APPENDIX C

Comments and Responses

89 **Fairfield to Dupuyer**
CORRIDOR STUDY

Public Hearing: Choteau - Thursday November 14, 2002

Photo attachment

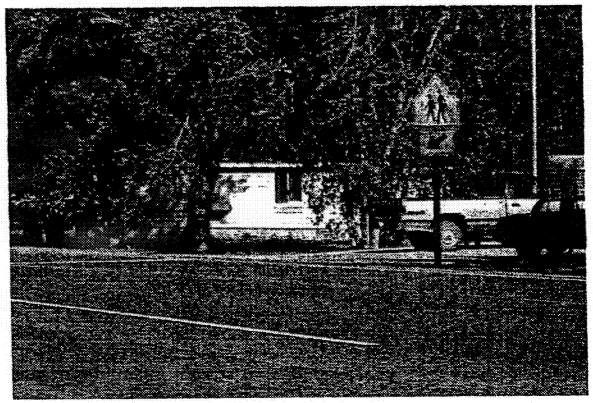
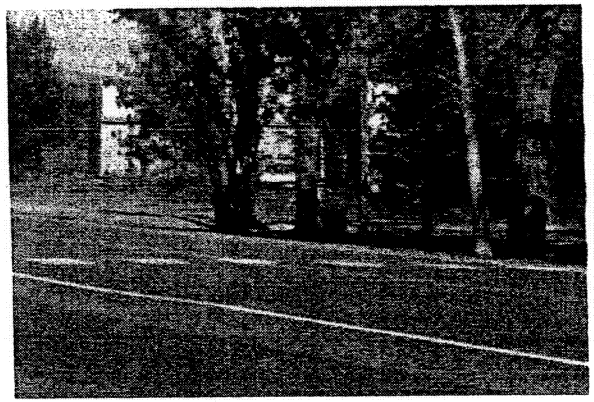
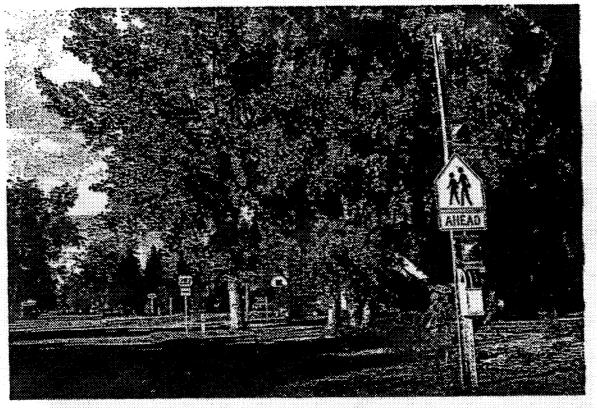
Crosswalk on highway at Fort Shaw. School is 1.5 miles by road from this crosswalk.

Crosswalk on highway at Choteau. Absolutely no sign exists. School is 8/10 of a mile from crosswalk.

Clear signs on crosswalks in Dutton.

White painted lines on Highway 200 by Fort Shaw.

Painted lines on Highway 89 in Choteau. I was led to believe that all of the crosswalks had to be standard painting and signage when I called last month with concerns. The crosswalk by the school in Choteau has very thin lines in an X pattern.

Crosswalks in Dutton with clear signs and thick paint.

Crosswalk near school in Choteau, only has a flashing school crossing sign at south end of school.

I would like to see a true stop light on Main Street in Choteau, with a "walk" light. I would like our crosswalks CLEARLY marked, particularly on Main Street and near the courthouse. I would also like to see the "kink" in the road remain. I live at 4219 Hwy 89 N and vehicles come by my house going way too fast. I believe the curve helps slow down traffic heading south into Choteau.

Response # 64
The intersection will be re-striped as early as the fall of 2003 as part of the safety improvement project that will also include the four-way stop.
